# 2018 Changes to International Codes

## IBC - FIRE SAFETY - FIRE TAC

**2018 International Building Code (IBC – Fire Safety)  
Fire TAC**

#### Section: Table 705.2

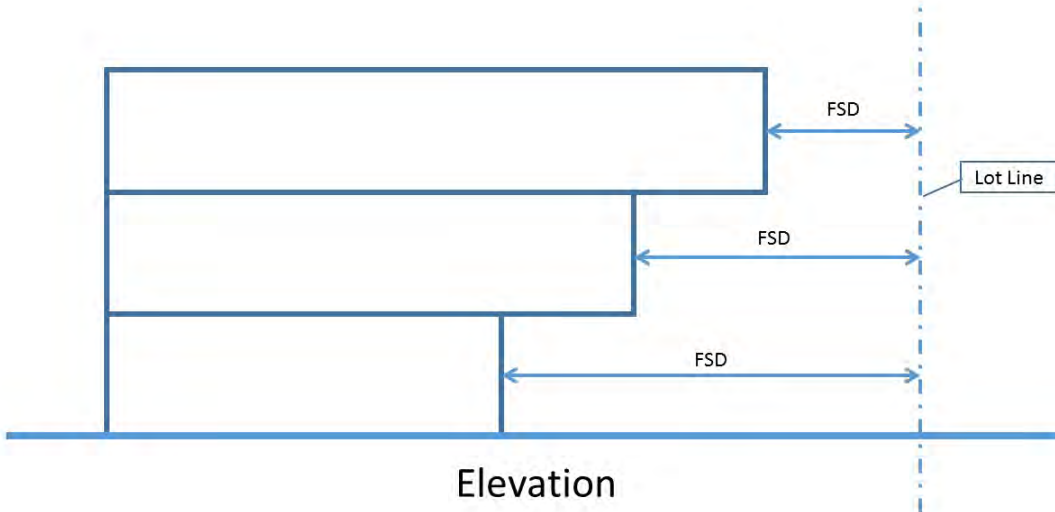
**Proponent:** Stephen Thomas, representing Colorado Chapter (sthomas@coloradocode.net)

#### Revise as follows:

**705.8.1 Allowable area of openings.** The maximum area of unprotected and protected openings permitted in an *exterior wall* in any *story* of a building shall not exceed the percentages specified in Table 705.8 based on the fire separation distance of each individual story.

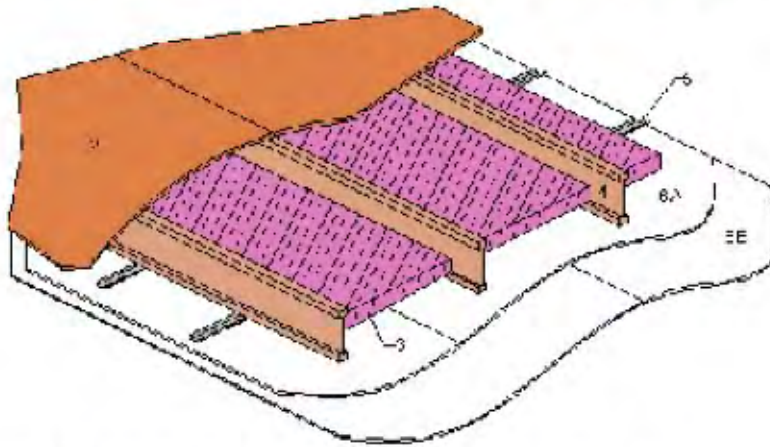
**Reason:** This proposal, in our opinion, is an editorial change as it simply is provided to correct what is currently specified in the 2015 IBC. The current text entry as published in the 2015 IBC is not correctly shown as the current code does not specify the resilient channel requirement as shown in the following link and the figure shown in the reason. This figure was referenced in the AWC code proposal submitted last code cycle and approved by the membership. ([http://www.awc.org/publications/dca/dca3/WIJ-1.7.1-joist\\_2-layers\\_with\\_RCs.htm](http://www.awc.org/publications/dca/dca3/WIJ-1.7.1-joist_2-layers_with_RCs.htm))

The reason statement for including this proposal previously in the 2015 IBC stated:

Many code officials have come to rely upon Table 720 as the preferred source of information regarding fire resistance rated assemblies. Because of its importance, we believe that the table should offer the most common generic assemblies. Floor systems utilizing I-joists have increased from less than 10 percent in 1990 to more than 50 percent. With the increased prevalence of I-joist floor/ceiling assemblies, including this assembly in the table will make the IBC more complete and it will be more useful to code officials. It is also expected that the document will be "user friendly", particularly for designers. In an effort to fulfill this expectation, we propose this common assembly for incorporation into Table 720.1(3). It is supported by ASTM E-119 test results as shown on the attached page. The following information and test results are provided with the understanding that their inclusion does not place them within the copyright release requirements of the signature statement.

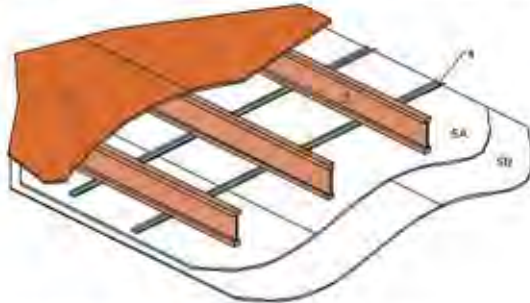
FLOOR OR ROOF CONSTRUCTION	ITEM NUMBER	CEILING CONSTRUCTION	THICKNESS OF FLOOR OR ROOF SLAB (inches)				MINIMUM THICKNESS OF CEILING (inches)			
			4 hours	3 hours	2 hours	1 hour	4 hours	3 hours	2 hours	1 hour
		spaced 8" o.c. placed 6" from face layer end joints. Face layer wallboard joints to be taped and covered with joint compound.

(Portions of table and footnotes not shown remain unchanged)

**Reason:** This proposal, in our opinion, is an editorial change as it simply is provided to correct what is currently specified in the 2015 IBC. The current text entry as published in the 2015 IBC is not correctly shown as the current code does not specify the resilient channel requirement as shown in the following link and the figure shown in the reason. This figure was referenced in the AWC code proposal submitted last code cycle and approved by the membership. ([http://www.awc.org/publications/dca/dca3/WIJ-1.6.I-joist\\_2-layers\\_with\\_RCs.htm](http://www.awc.org/publications/dca/dca3/WIJ-1.6.I-joist_2-layers_with_RCs.htm))
